COLUMBIA AVENUE AND IOWA AVENUE STREET IMPROVEMENT PROJECT

CITY OF RIVERSIDE
COLUMBIA AVENUE AND IOWA AVENUE
STREET IMPROVEMENT PROJECT
COVER SHEET

SHEET 1 OF 76

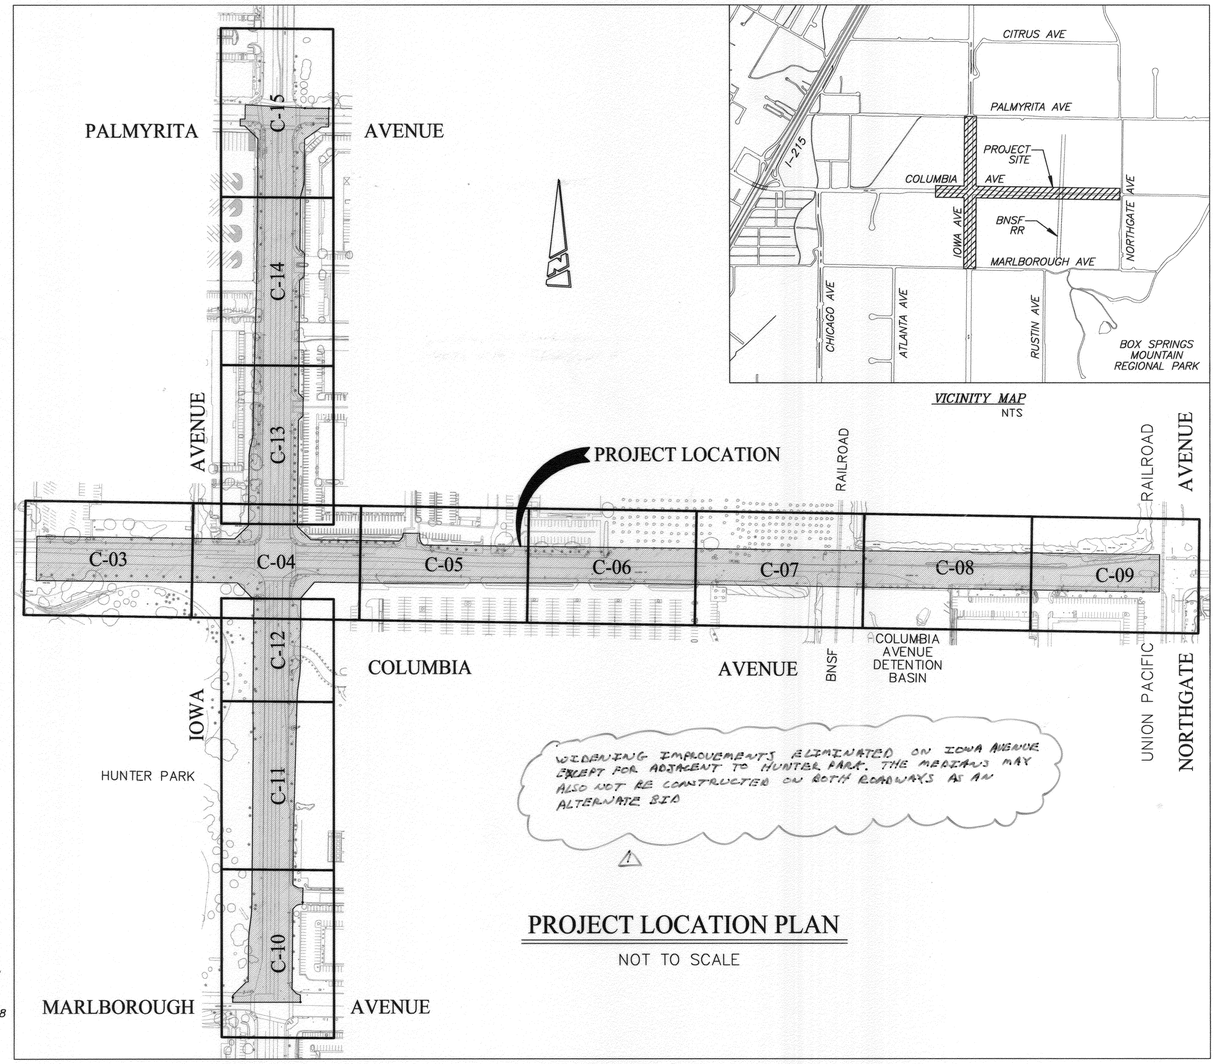
- G1 — ADJUST GAS MANHOLE TO GRADE (BY GAS COMPANY)
- G2 — RELOCATE GAS VAULT (BY GAS COMPANY)
- C S1 — CONSTRUCT AC PAVEMENT ~~(0.55' AC OVER 1.35' AB)~~ 0.14'ARHM/0.43 DGAC/1.35 CAB

- C S2 — CONSTRUCT AC PAVEMENT ~~(0.55' AC OVER 0.90' AB)~~ 0.14'ARHM/0.45 DGAC/0.90 CAB
- C S3 — CONSTRUCT AC PAVEMENT ~~(0.70' AC OVER 1.05' AB)~~ 0.14'ARHM/0.60 DGAC/1.05 CAB

- C S4 — CONSTRUCT AC PAVEMENT ~~(0.60' AC OVER 1.45' AB)~~ 0.14'ARHM/0.50 DGAC/1.45 CAB
- C S6 — CONSTRUCT AC PAVEMENT ~~(0.60' AC OVER 0.70' AB)~~ 0.14'ARHM/0.50 DGAC/0.70 CAB

- C S7 — CONSTRUCT AC PAVEMENT ~~(0.80' AC OVER 1.40' AB)~~ 0.14'ARHM/0.70 DGAC/1.40 CAB
- PIP — PROTECT IN PLACE (DESCRIPTION PER PLAN)

IOWA AVENUE

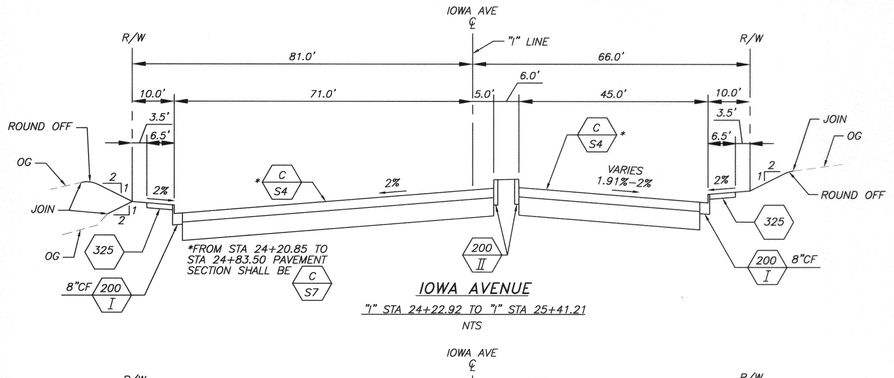
*FROM STA 24+20.85 TO STA 24+83.50 PAVEMENT SECTION SHALL BE C S7

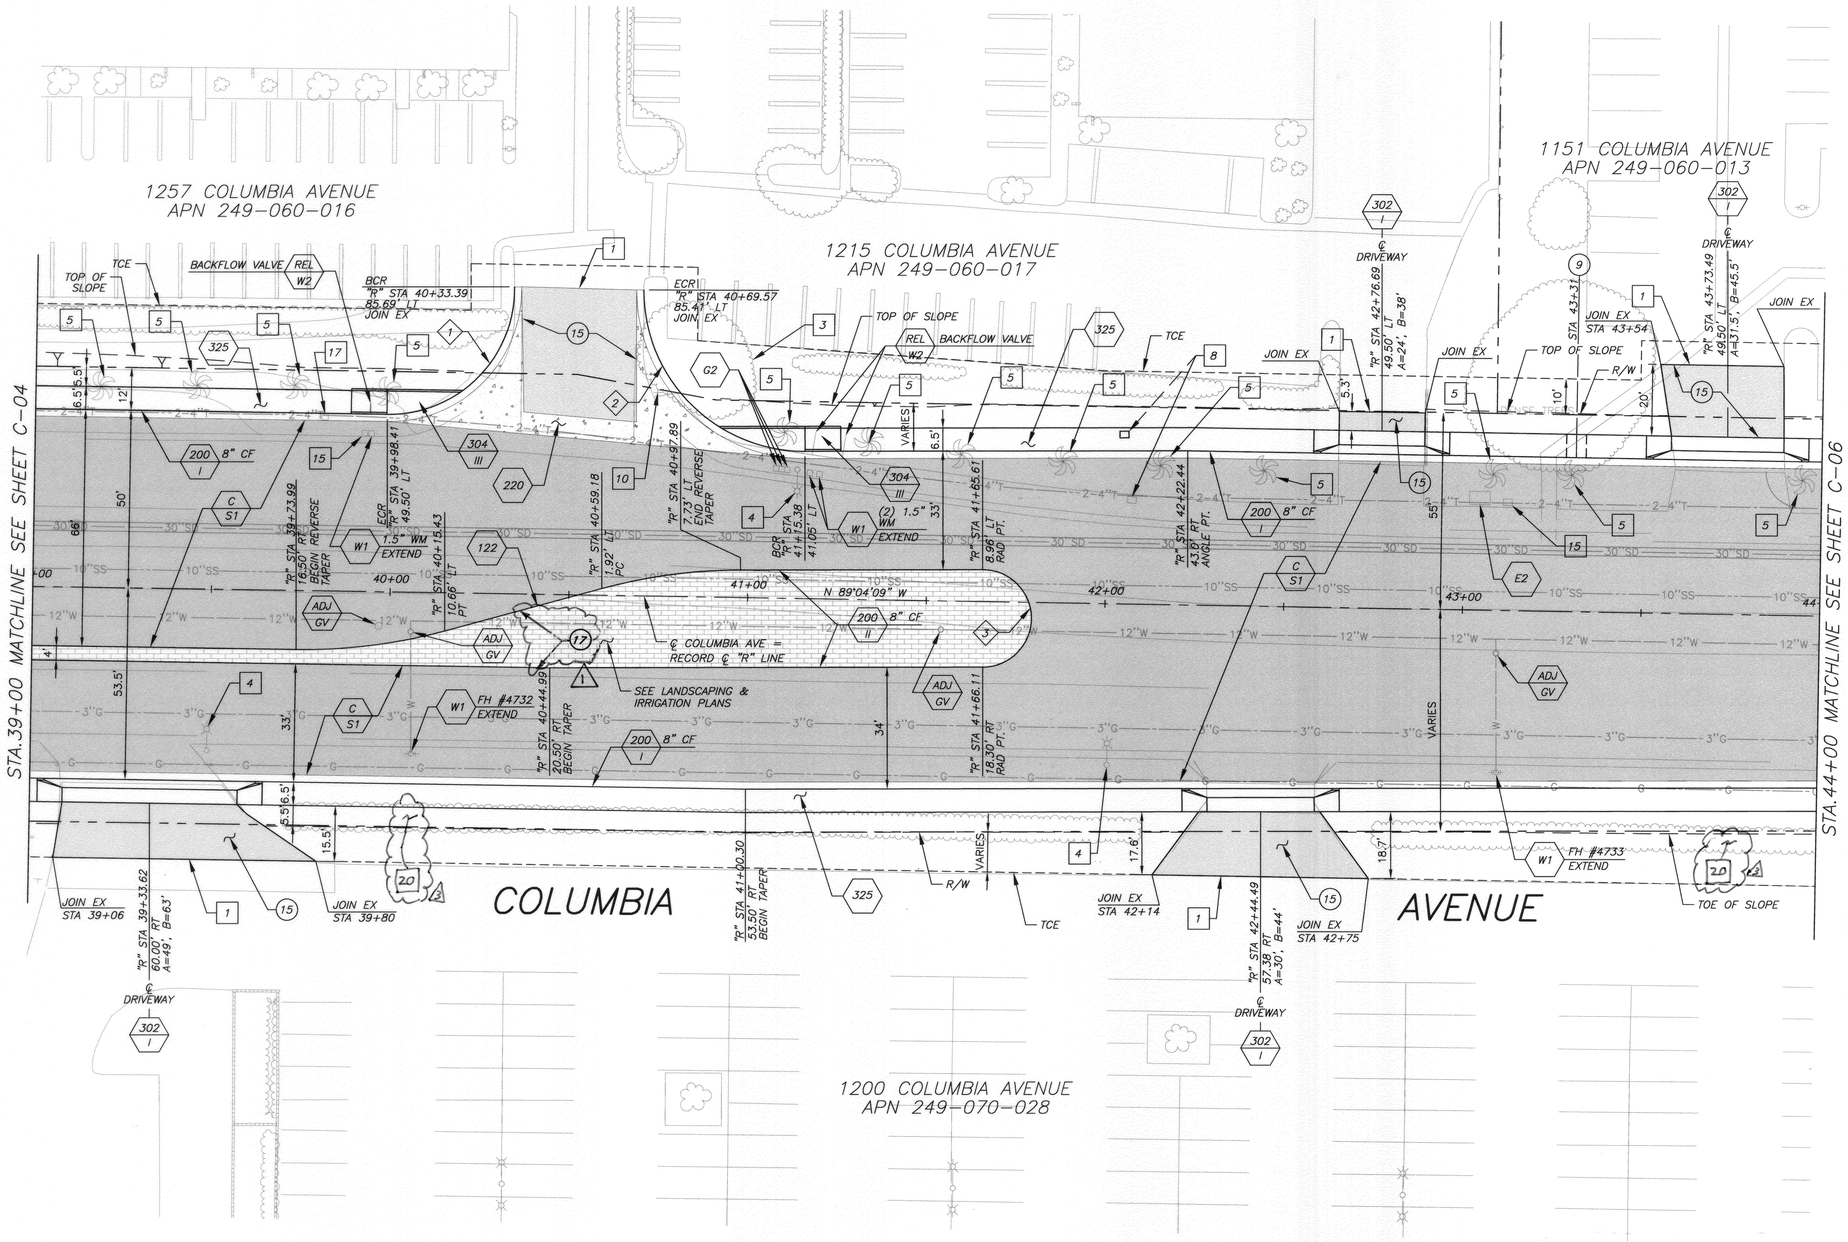
C S1	CONSTRUCT AC PAVEMENT ~~(0.55' AC ON 1.35' AB)~~ 0.18'AR-HMA/0.45'DGAC/1.35 CAB (2)
ADJ GV	ADJUST WATER GATE VALVE AND COVER TO GRADE
W1	PUD, WATER DIV. TO EXTEND LATERAL AND RELOCATE FIRE HYDRANTS, AIR RELEASE VALVES, WATER METERS, BACKFLOW VALVES, WATER VAULTS AND VENT PIPES
REL W2	RELOCATE WATER FACILITY BY PRIVATE CONTRACTOR, ITEM AS INDICATED
E2	PUD, ELECTRIC DIV. TO ADJUST VAULTS AND BOX TO GRADE OR RELOCATE PRIOR TO CONSTRUCTION
G2	RELOCATE GAS VAULT (BY GAS COMPANY)
9	CONSTRUCT PARKWAY DRAIN PER APWA STANDARD PLAN 151-1
15	MATCH EXISTING AC PAVEMENT THICKNESS, MINIMUM 4"

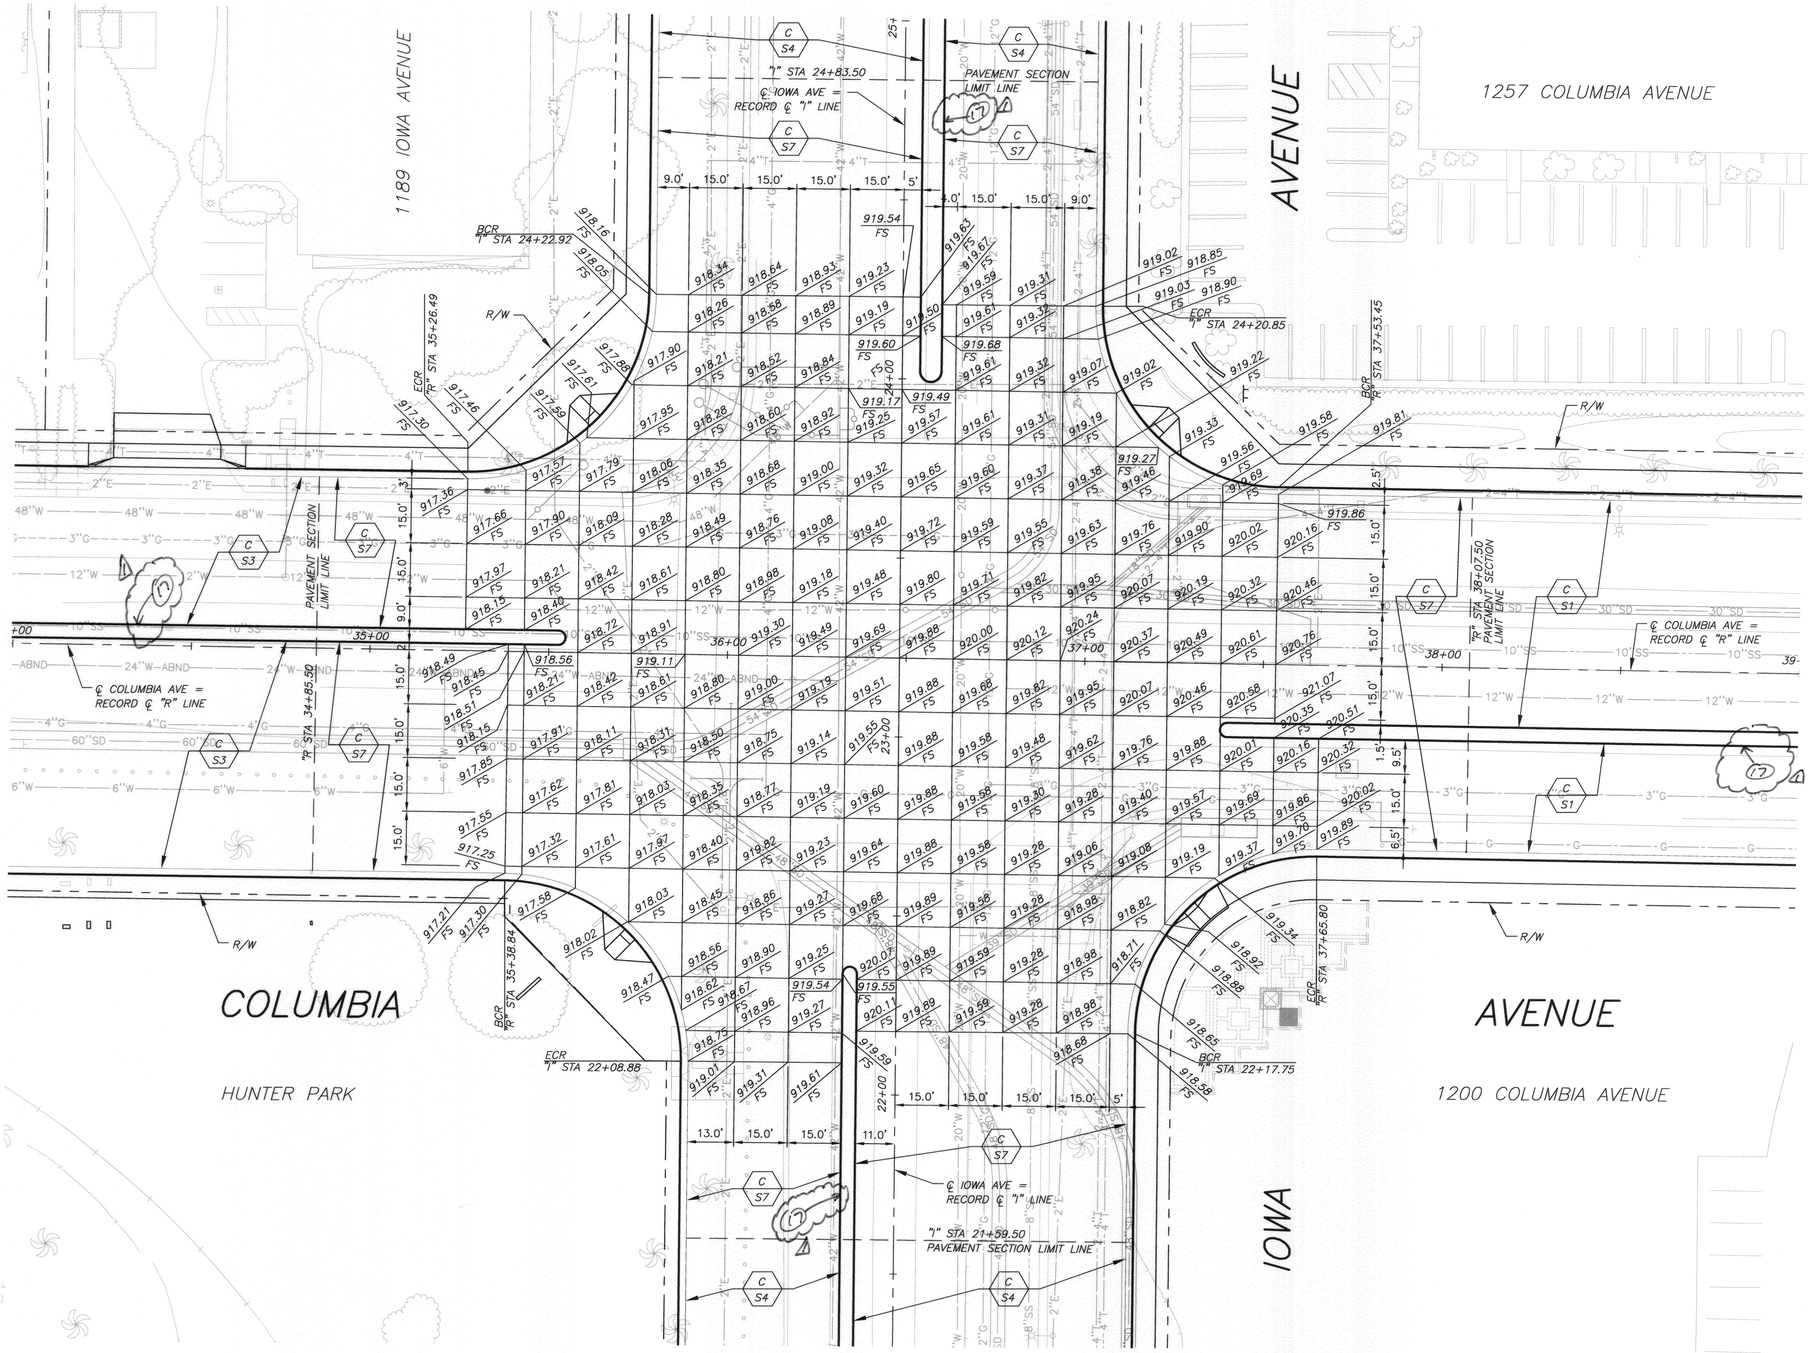
(17) PROPOSED MEDIANS INDICATED TO BE CONSTRUCTED AS PART OF BASE BID ~~(BID)~~ BUT MAY BE REPLACED WITH NEW AC PAVEMENT AS PART OF ALTERNATE BID

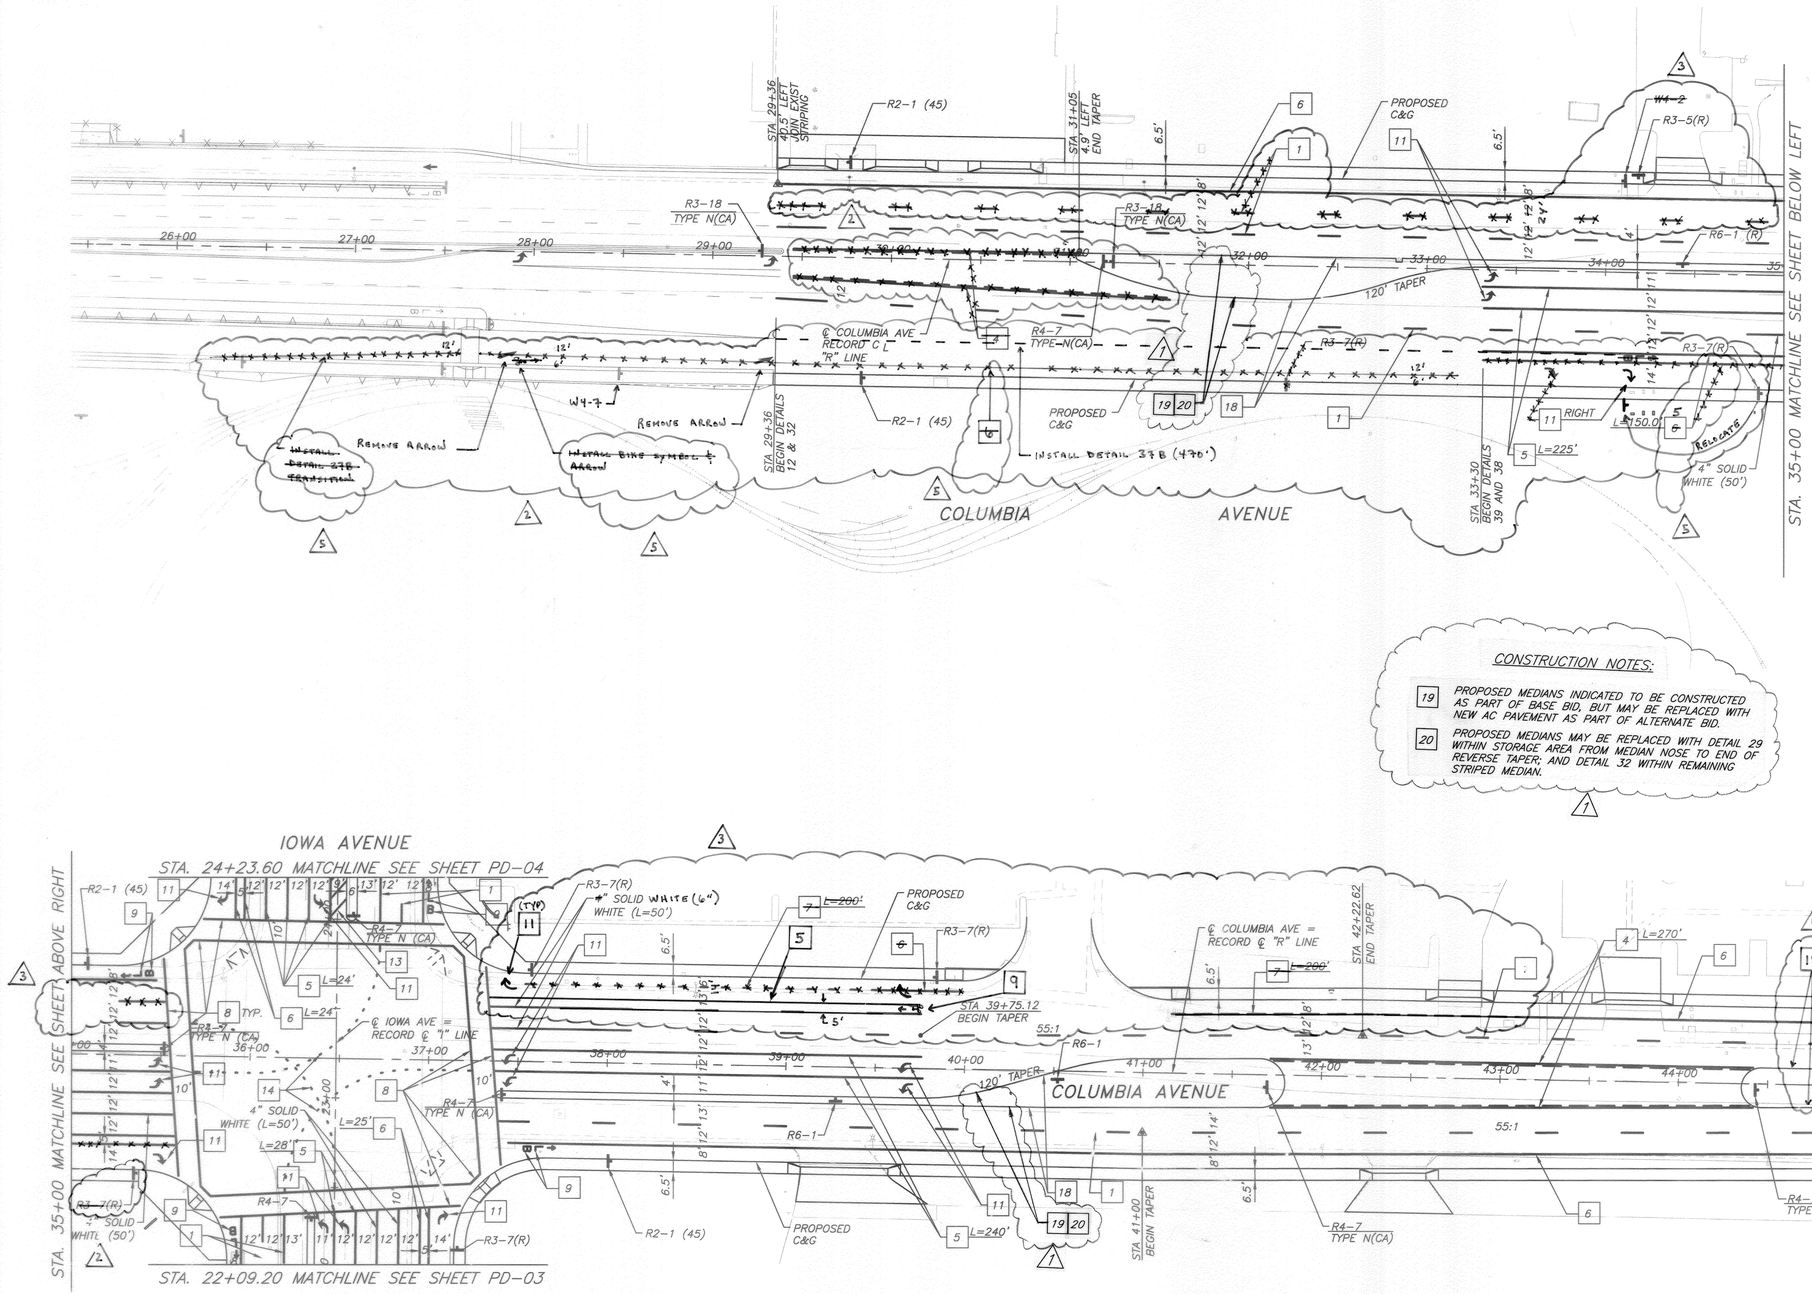
1	INSTALL DETAIL 12	8	INSTALL 12" WHITE LINE
3	INSTALL DETAIL 27B	9	INSTALL "BIKE LANE" & TYPE I ARROW SYMBOL
4	INSTALL DETAIL 32	11	INSTALL TYPE IV ARROW (DIRECTION AS INDICATED)
5	INSTALL DETAIL 38	14	INSTALL DETAIL 40
6	INSTALL DETAIL 39	18	INSTALL DETAIL ~~26~~ 25A
7	INSTALL DETAIL 39A

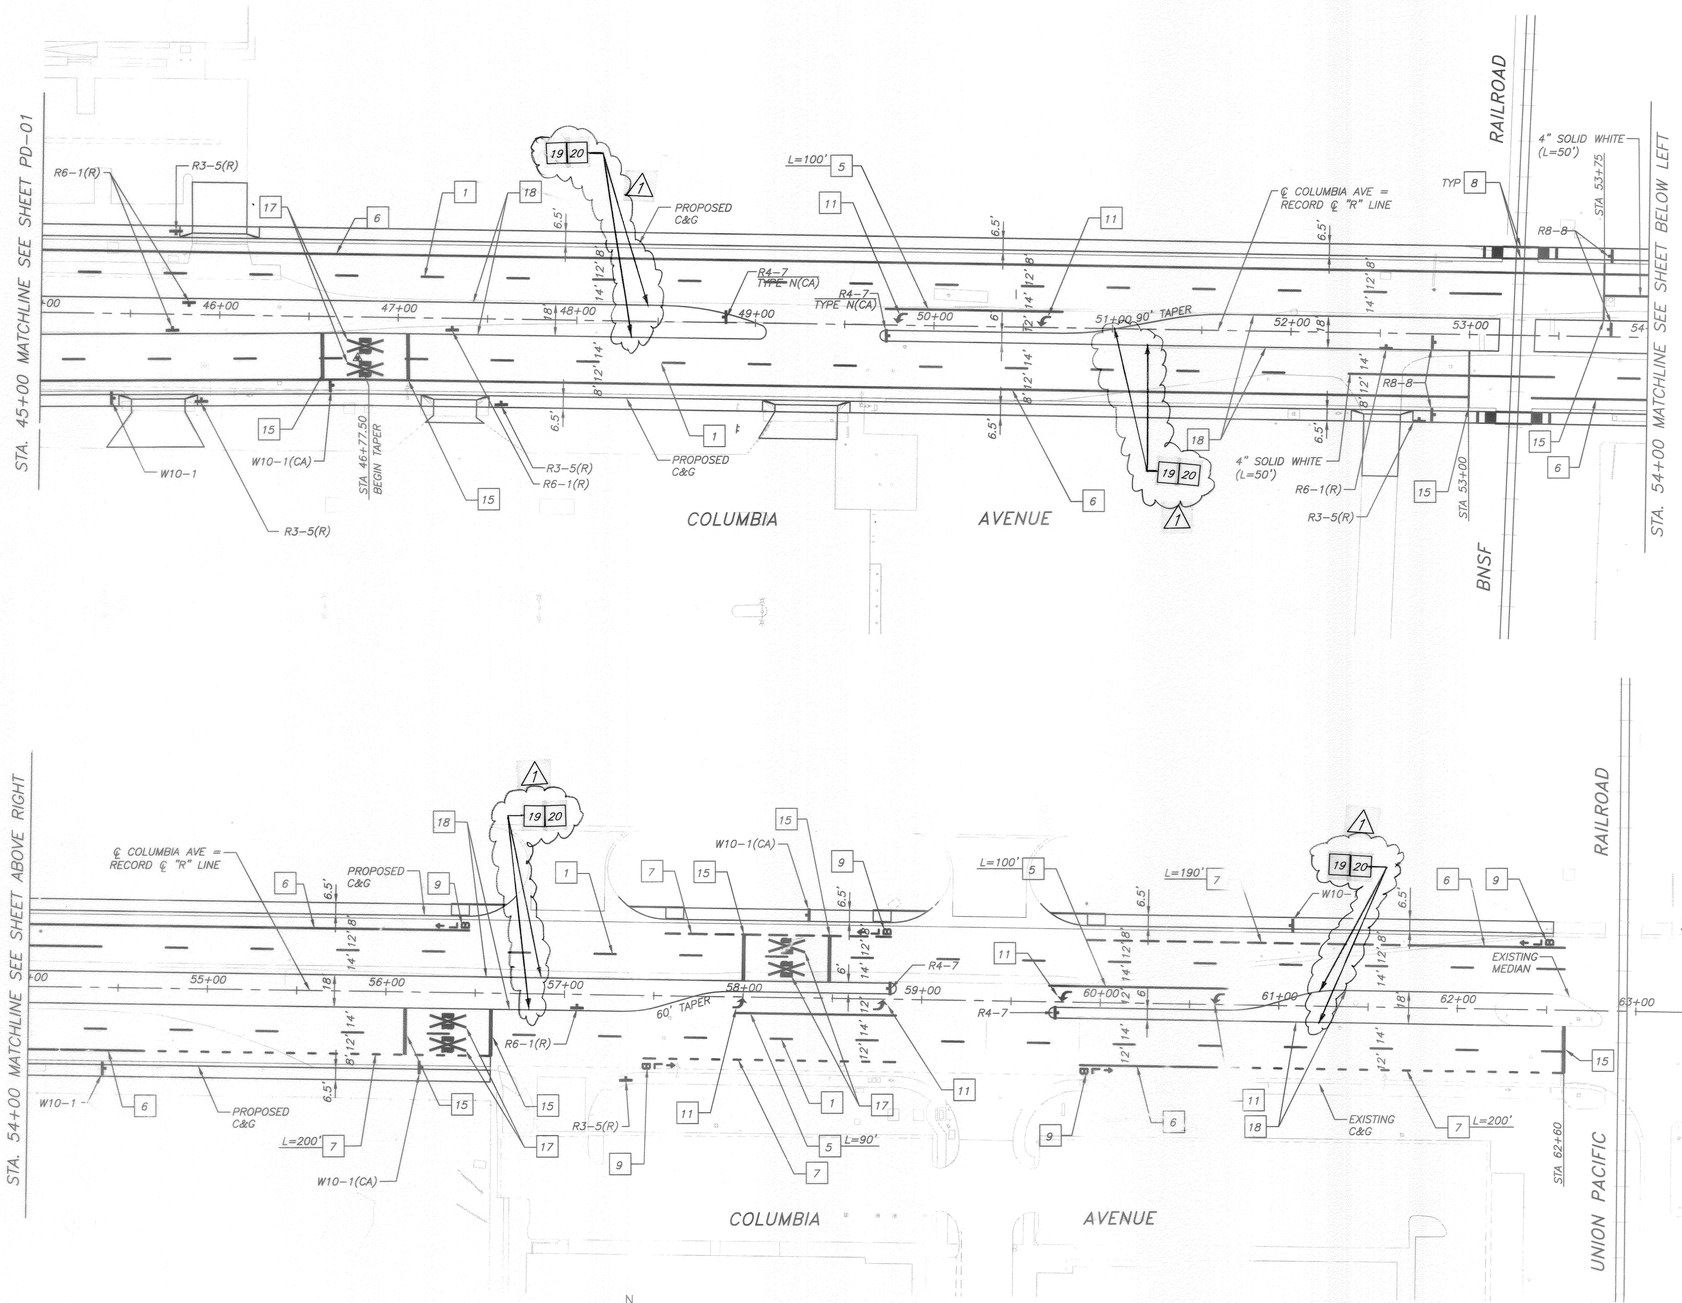
1	INSTALL DETAIL 12	11	INSTALL TYPE IV ARROW (DIRECTION AS INDICATED)
5	INSTALL DETAIL 38	15	INSTALL 24" SOLID WHITE
6	INSTALL DETAIL 39	17	INSTALL "RXR"
8	INSTALL 12" WHITE LINE	18	INSTALL DETAIL ~~26~~ 25A 2
9	INSTALL "BIKE LANE" & TYPE I ARROW
